Intersection ID: 44730	Main Street: BENFIELD_RD	Cross Street: KOTLIK_DR	Location:	N
ADA ID: E9375BDFA75D	Ramp Type: Para	Initial Pass/Fail: Fail	Overall Compliance: No	Severity Score: 25

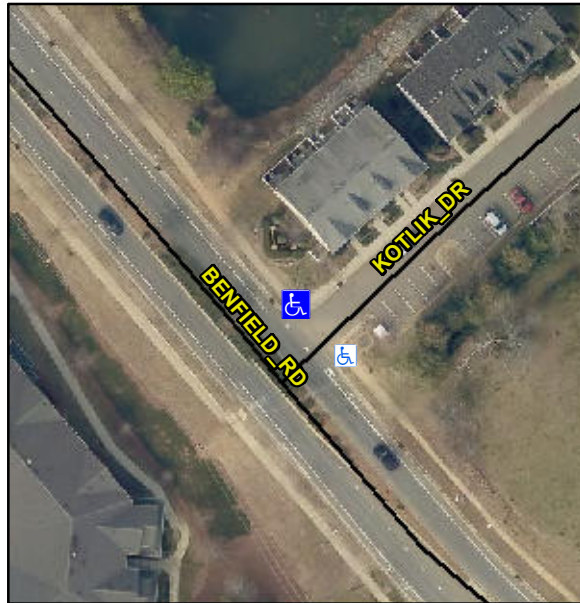
### Remove & Replace Entire Ramp.

### R304.3.2

Compliance	Description	Data	Compliance	Description	Data
N/A	Ramp Length LT (in)	N/A	N/A	Ramp Length RT (in)	50.0
N/A	Ramp Width LT (in)	N/A	Yes	Ramp Width RT (in)	68.0
N/A	Ramp Slope LT (%)	N/A	No	Ramp Slope RT (%)	16.1
N/A	Ramp XSlope LT (%)	N/A	Yes	Ramp XSlope RT (%)	0.0
N/A	Landing Length (in)	N/A	N/A	DWS Provided?	N/A
N/A	Landing Width (in)	N/A	N/A	DWS Contrast?	N/A
N/A	Landing Slope (%)	N/A	N/A	DWS Length (in)	N/A
N/A	Landing X Slope (%)	N/A	N/A	DWS Full Width?	N/A
N/A	Landing Curb? (Y/N)	N/A	N/A	DWS Offset (in)	N/A
N/A	Shared Landing?	N/A			
N/A	Gutter Ponding?	N/A	N/A	Gutter Slope (%)	N/A
N/A	Gutter Lip Ht (in)	N/A	N/A	Gutter X Slope (%)	N/A
N/A	Painted X Walk1?	No	N/A	Painted X Walk2?	N/A
	X Walk 1 Direction	To SE		X Walk 2 Direction	N/A
N/A	X Walk 1 Width (in)	N/A	N/A	X Walk 2 Width (in)	N/A
	X Walk 1 Slope (%)	1.6		X Walk 2 Slope (%)	N/A
	X Walk 1 X Slope (%)	7.1		X Walk 2 X Slope (%)	N/A
N/A	Ramp inside XWalk1?	N/A	N/A	Ramp inside XWalk2?	N/A
